IN THE MATTER OF THE APPLICATION
OF ARIZONA WATER COMPANY, AN
ARIZONA CORPORATION, TO EXTEND
ITS EXISTING CERTIFICATE OF
CONVENIENCE AND NECESSITY AT
CASA GRANDE, PINAL COUNTY,
ARIZONA

REQUEST FOR ADDITIONAL TIME FOR
COMPLIANCE FILING

**Re: Application for a Physical Availability Determination
Arizona Water Company - Pinal Valley Water Service Area (DWR No. 51-700444.0000)
Administrative Completeness Review**

**DRAFT Response to Administrative Completeness Review (dated November 20, 2008)
Application for a Physical Availability Demonstration Item Nos. 3 to 8
Arizona Water Company - - Pinal Valley Water Service Area (ADWR File No. 51-
700444.0000)**

Figure 1 – Simulated Northwest Boundary per Model Layer

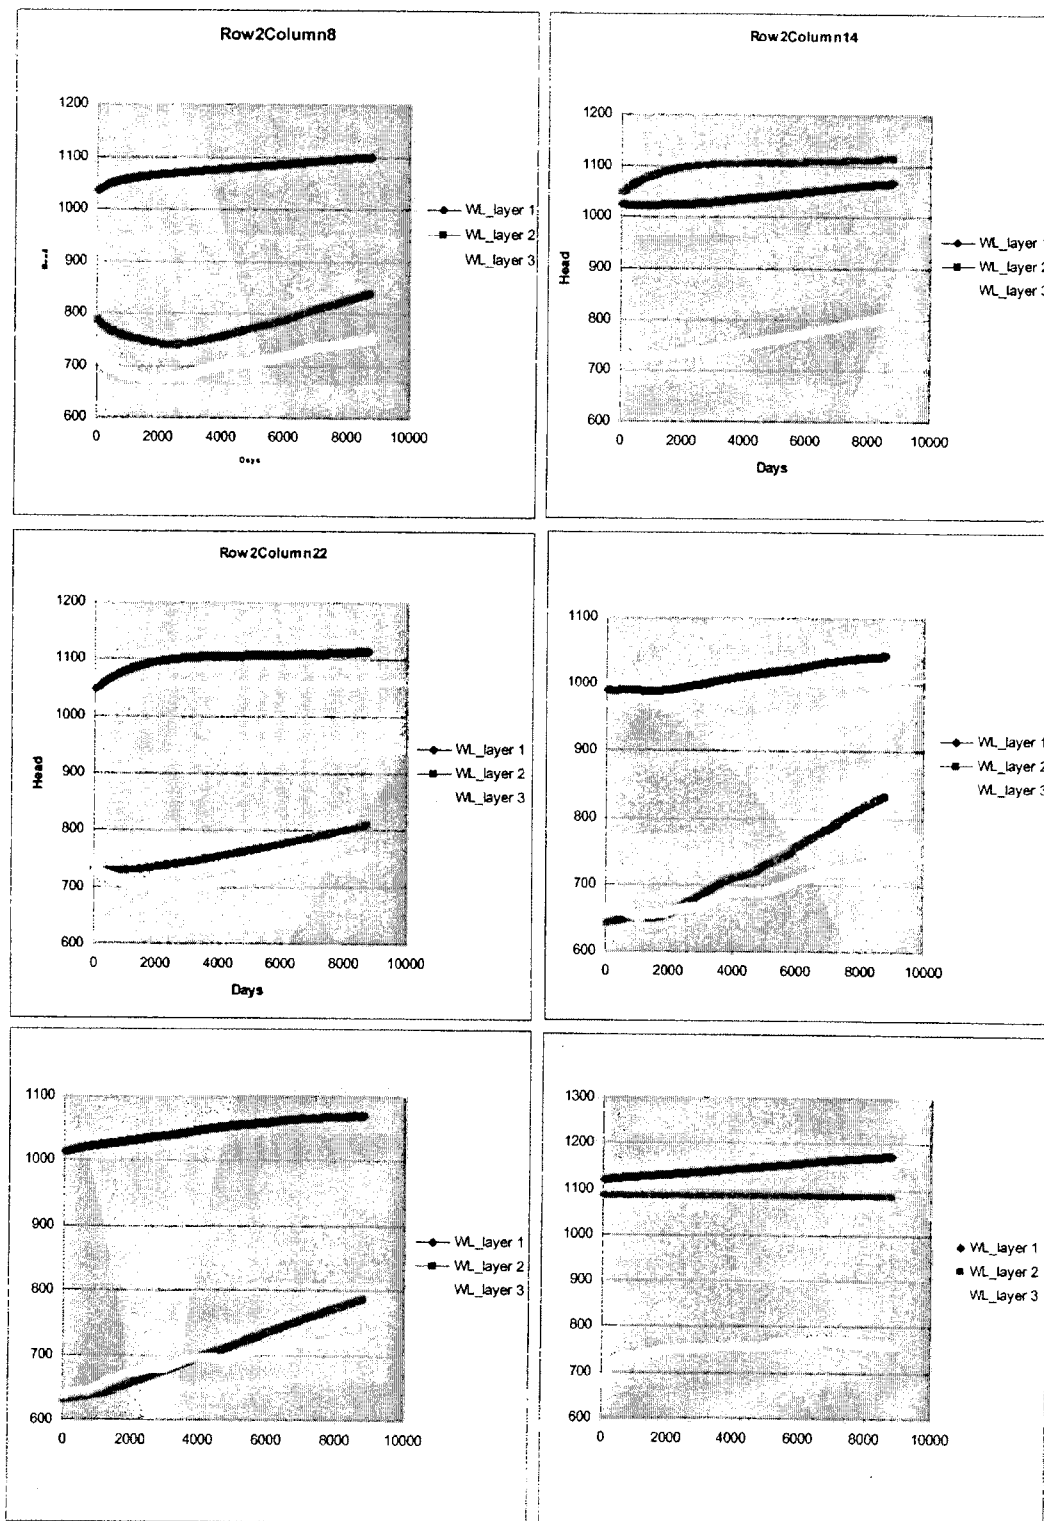
Groundwater underflow through the Florence gap and the gap between the Santan and Sacaton Mountains were simulated through general head boundaries (GHB). However, these two

boundaries were only assigned in model layer 3. No GHB boundaries were specified in model layer 1, and only the GHB boundary at the Florence gap was simulated in model layer 2. The applicant must justify the need for the different configurations for the 3 model layers.

Figure 2 – Components of Agricultural Recharge within re-submitted AWC Model

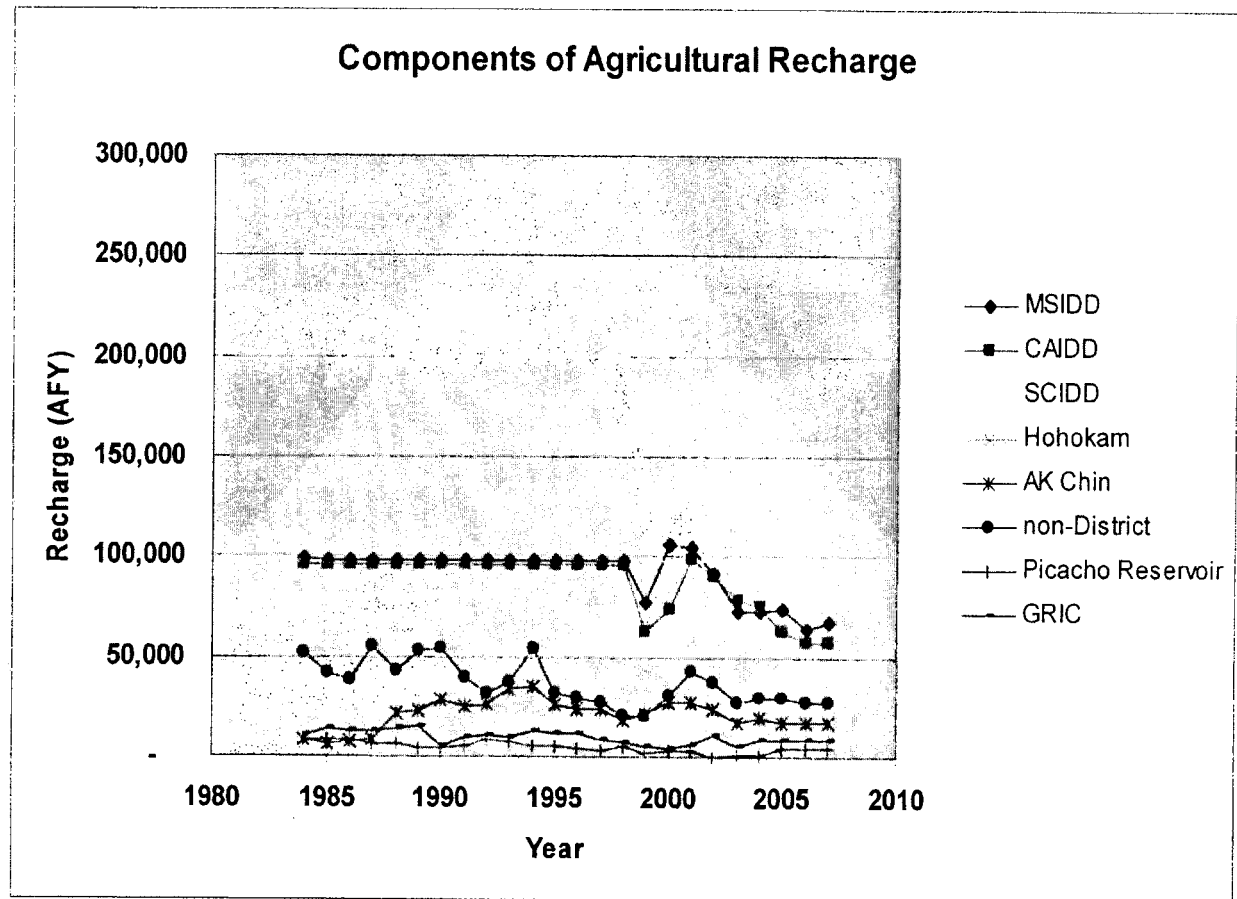
By accounting for the impact of the agricultural recharge lag time, which is assumed to be 20 years in the revised modeling report, the agricultural recharge was increased significantly. The agriculture recharge simulated in the revised model ranges from 261,707 AFY to 574,053 AFY. When the lag time is not considered, the conceptual agricultural recharge reported in the previous AWC modeling report ranges from 204,717 AFY to 377,129 AFY. The maximum increase of agriculture recharge was as much as 301,126 AFY in 1993. Initial estimate of the agricultural recharge by considering a 20 year lag time ranges from 198,000 AFY and 468,400 AFY. The calibrated agricultural recharge exceeds the initial estimate for all the years of the transient model (1984~2007). The agricultural recharge was over simulated and must be re-conceptualized.

A constant agricultural recharge was simulated for SCIDD, CAIDD, MSIDD, and HOHOKAM from early 1980s to 1998. After 1998, the estimated agricultural recharge for each of the irrigation districts started to fluctuate. The applicant is required to include discussions in the report to address this temporal recharge distribution (see Figure 2).
